TURKEY POINT NUCLEAR GENERATING UNIT NO. 3

Amendment No. 47
License No. DPR-31

Amendment No. 39
License No. DPR-41

SAFETY EVALUATION BY THE OFFICE OF NUCLEAR REACTOR REGULATION

FIGURE 3.2-1

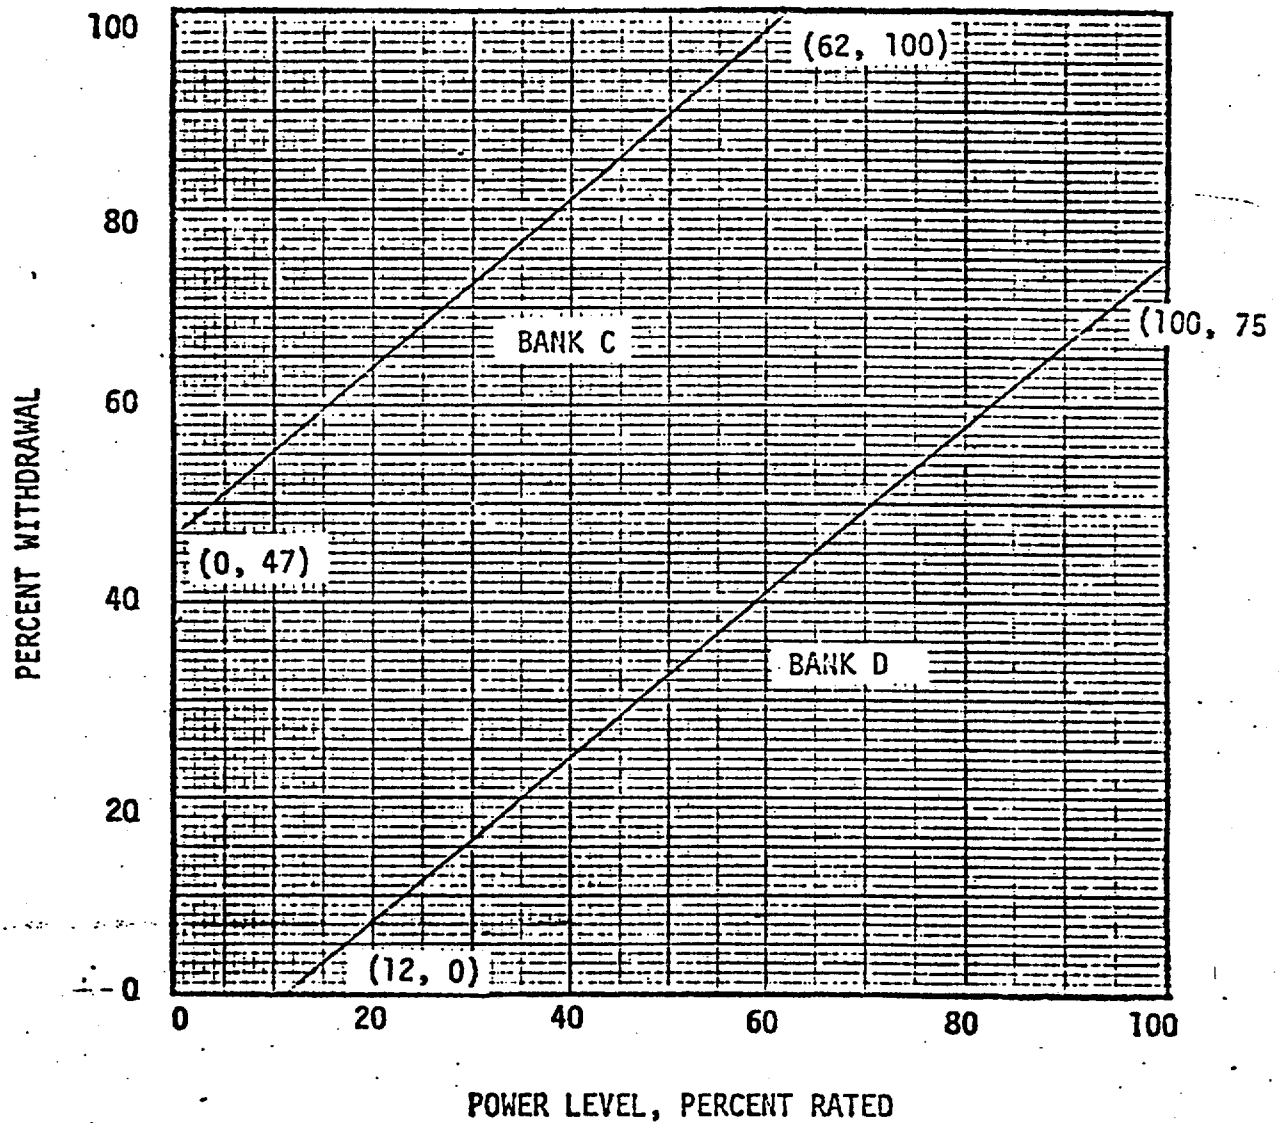
These amendments change the control rod group insertion limits. Paragraphs 6.2.2.f and 6.4.2 were unintentionally left off page 6-5 when that page was revised on February 15, 1979 (Amendment 43 for Unit 3 and Amendment 35 for Unit 4). These amendments correct that administrative error.

The control rod insertion limits are established to ensure that (1) adequate shutdown margin exists, (2) hot channel factors are maintained below design limits and (3) the consequences of a rod ejection accident are acceptable. Insertion limits are determined to give the lowest rod positions which meet these criteria. The Technical Specifications state that the control group rods shall be no further inserted than the limits shown on Figures 3.2-1 and Figures 3.2-1 (a), (b) and (c).

The proposed control rod insertion limits would allow the control group rods to be inserted into the reactor core a lesser amount than do the existing Technical Specification limits. A decrease in the amount of allowed insertion is conservative. It would increase the minimum available shutdown margin, maintain an acceptable core power distribution and decrease the consequences of a control rod ejection accident.
